TELEVISION TECHNICAL BULLETIN

MODELS 66GS62H

Reference SP022102X

Figure 1: Mother Unit F7315BMN6, Copper Side.

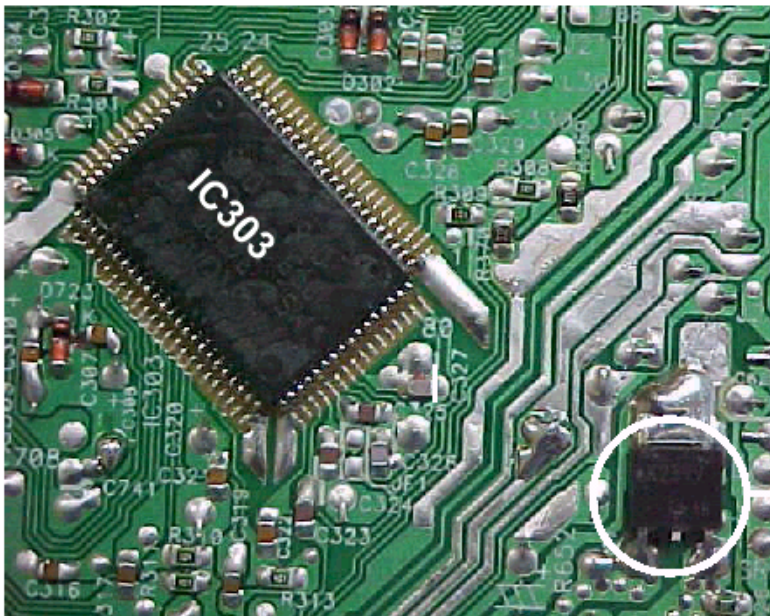
1. De-solder the old part(Q610 SMD: RH-TX0240BMZZ). See figure 1.
2. Mount the new part (Q610 Radial: RH-TX0246BMZZ). See figure 2 and 3.

— OLD Q610, SMD
(RH-TX0240BMZZ)

Figure 2: Mother Unit F7315BMN6, Component Side.

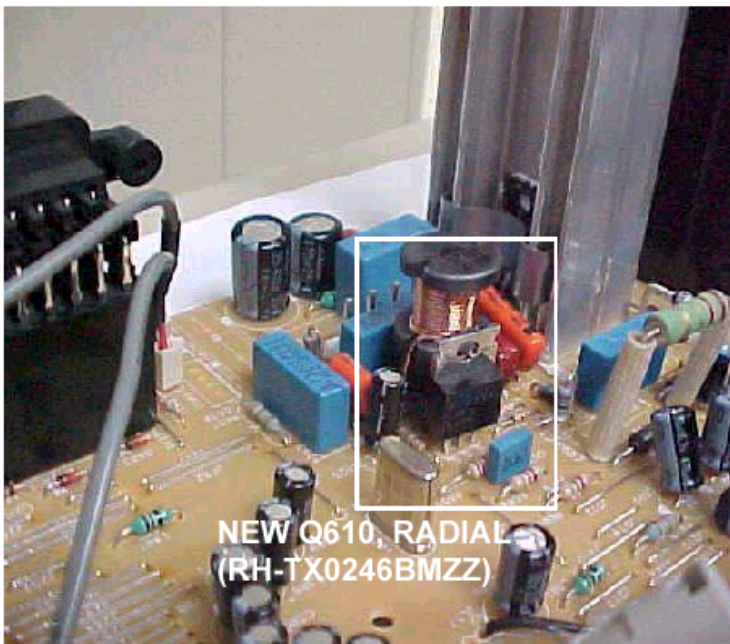
NEW Q610, RADIAL
(RH-TX0246BMZZ)

ACTION Q610 should be changed, it should be replaced with the new type (RH-TX0246BMZZ) using the following procedure:
